UNITED STATES PATENT AND TRADEMARK OFFICE

10/632,273

Office Action Summary

DETAILED ACTION

Figure A

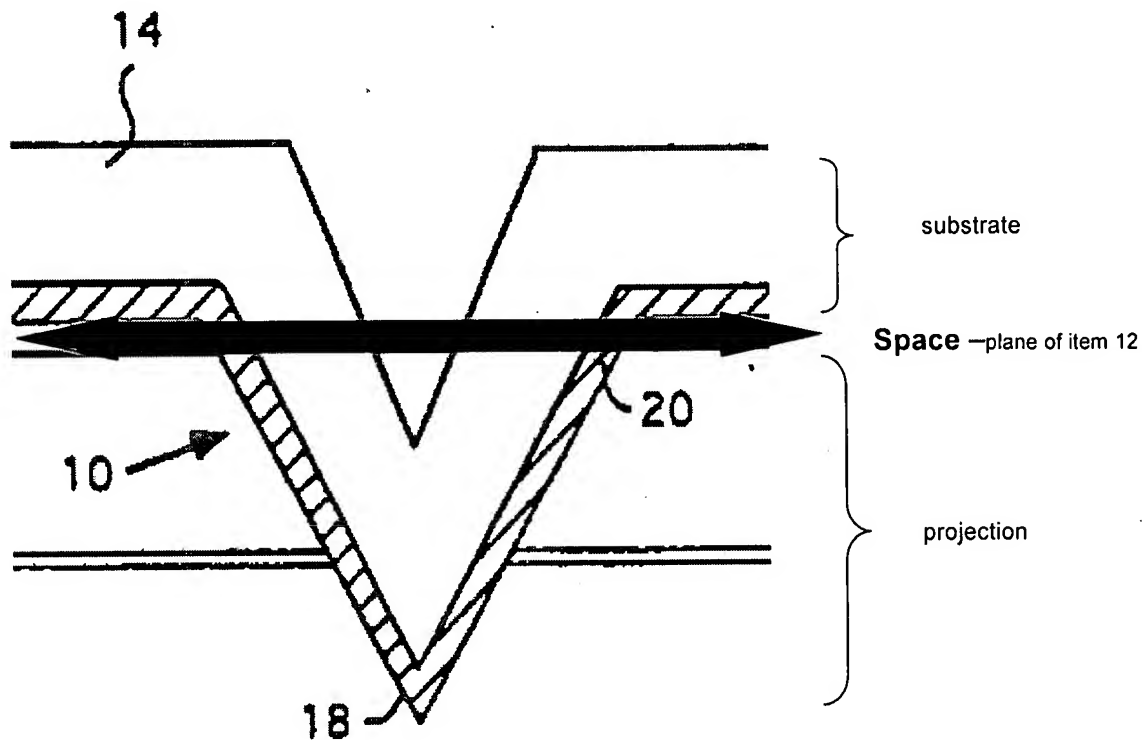
As to claim 56, Leedy shows in Figure 2 an intermediate structure (that portion of 14 between the substrate and the projection, see **Space** in Figure A below), providing spacing of the projection from the substrate comprising a lateral dimension that is different from a lateral dimension of the substrate and a lateral dimension of the projection (they all have different lateral lengths).

As to claim 55, Leedy shows in Figure 2 an intermediate structure (that portion of 14 between the substrate and the projection, see **Space** in Figure A above), providing spacing of the projection from the substrate comprising a lateral dimension that is different from a lateral dimension of the substrate and a lateral dimension of the projection (they all have different lateral lengths).

As to claim 59, Leedy shows in Figure 2 an intermediate structure (that portion of 14 between the substrate and the projection, see **Space** in Figure A), providing spacing of the projection from the substrate comprising a lateral dimension that is different from a lateral dimension of the substrate and a lateral dimension of the projection (they all have different lateral lengths).
